Access Compliance Report

Public Rights-of-Way

Intersection ID: 28868	Main Street: BIRDWELL_CT	Cross Street: SUTTONVIEW_DR	Location: W
ADA ID: B26975E10B0D	Ramp Type: PerpDiag	Initial Pass/Fail: Fail	Overall Compliance: No
Severity Score: 1.25			
Codes/Mitigation Info/Possible Solution		Field Measurements/Component Compliance

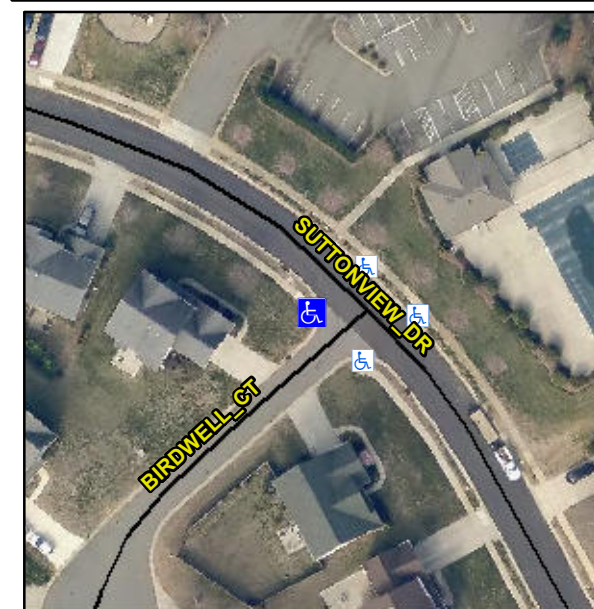
Not Found, R304.5.3

Compliance	Description	Data	Compliance	Description	Data
N/A	Ramp Length (in)	36.0	Yes	Ramp Slope (%)	5.0
Yes	Ramp Width (in)	54.0	No	Ramp XSlope (%)	4.6
N/A	Flare Type LT	N/A	N/A	Flare Type RT	N/A
N/A	Flare Slope LT (%)	N/A	N/A	Flare Slope RT (%)	N/A
N/A	Flare Traversable LT?	N/A	N/A	Flare Traversable RT?	N/A
N/A	Landing Length (in)	N/A	N/A	DWS Provided?	N/A
N/A	Landing Width (in)	N/A	N/A	DWS Contrast?	N/A
N/A	Landing Slope (%)	N/A	N/A	DWS Length (in)	N/A
N/A	Landing X Slope (%)	N/A	N/A	DWS Full Width?	N/A
N/A	Landing Curb? (Y/N)	N/A	N/A	DWS Offset (in)	N/A
N/A	Shared Landing?	N/A			
N/A	Gutter Ponding?	N/A	N/A	Gutter Slope (%)	N/A
N/A	Gutter Lip Ht (in)	N/A	N/A	Gutter X Slope (%)	N/A
N/A	Painted X Walk1?	No	N/A	Painted X Walk2?	No
	X Walk 1 Direction	To SE		X Walk 2 Direction	To NE
N/A	X Walk 1 Width (in)	N/A	N/A	X Walk 2 Width (in)	N/A
	X Walk 1 Slope (%)	4.2		X Walk 2 Slope (%)	0.2
	X Walk 1 X Slope (%)	1.7		X Walk 2 X Slope (%)	3.9

Remove & Replace Curb Ramp With Two New Directional Ramps or Equivalent.
